Government of India
Ministry of Railways
Research, Designs & Standards Organisation
Manak Nagar, Lucknow - 226 011

Modification Sheet No. RDSO/WAM4/167

- 1. Title :** Modified adjustments punching for main pole core assembly of TAO - 659 Traction Motor.
- 2. Application :** All electric locomotives viz., WAM4, WAP1, WCAM1 & WAG5 fitted with TAO 659 Traction Motor.

REF:-	SCALE:- 1:1	APPROVED:-	FOR D.G.
ADJUSTMENT PUNCHING FOR MAIN POLE OF TAO-659 TRACTION MOTOR.			
RDSO. ELECT. DTE. SKEL - 4080

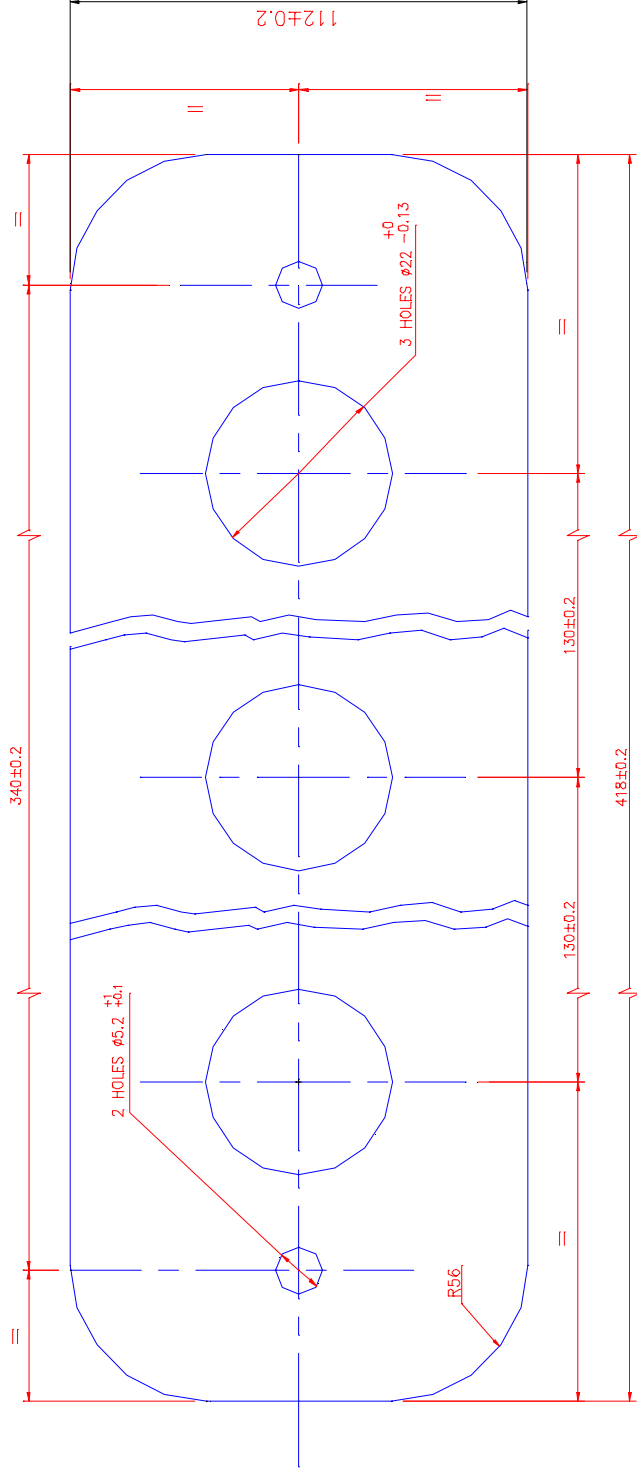
- 3. Object :**
 - 3.1 :** At present adjustment punching for main pole is being provided as per CLW Drg. No.3 TWD.092.091. The adjustment punching have sharp corners and likely to damage insulation partly at the time of assembly of coils. The sharp corners are also contributing to the failure of coils earthed in service due to vibration.

- 3.2 :** It is also observed that in some cases the adjustment punching are projecting over and above the main pole core punching both length wise as well as width wise. This also leads to partly damage of the coil insulation during assembly. The situation may also contribute to earthing of coils in service when coils are subjected to vibration.

- 3.3 :** The present modification intends to adopt the modified profile of adjustment punching for main pole to ensure that there are no sharp corners and avoid any possible damage during assembly/service.

- 4. Details of Modification :**
 - 4.1 :** Remove the present adjustment punching from main pole core assembly by cutting the rivets of 55 mm dia.
 - 4.2 :** Provide the modified adjustment punching having no sharp corners and smooth profile as shown RDSO's DRG No.4080 rivet the same in core assembly.

- 4.3 : The modified adjustment punching should be dye punched and have smooth surface/edges.
- 4.4 : Please check adjustment punching is not projecting beyond core.

- 4.5 : Material for the adjustment punching should be get checked as per relevant specification before acceptance of the material. Thickness of the punching should be such so as to ensure air gap within the limits laid-down.

- 1. ALL DIMENSIONS ARE IN MM.
- 2. MATERIAL MAGNETIC STEEL SHEET TO IS: 648-1980, GRADE A1120
- 3. THICKNESS OF PUNCHING 1mm:±0.2mm.
- 4. ALL SHARP CORNERS TO BE ROUNDED OFF.
- 5. THE PUNCHING SHALL BE MANUFACTURED WITH DIE PUNCHING AND SHOULD BE FREE FROM BURRS, SHARP CORNERS ETC.
- 6. TOLERANCES ±0.5 WHERE NOT SPECIFIED.
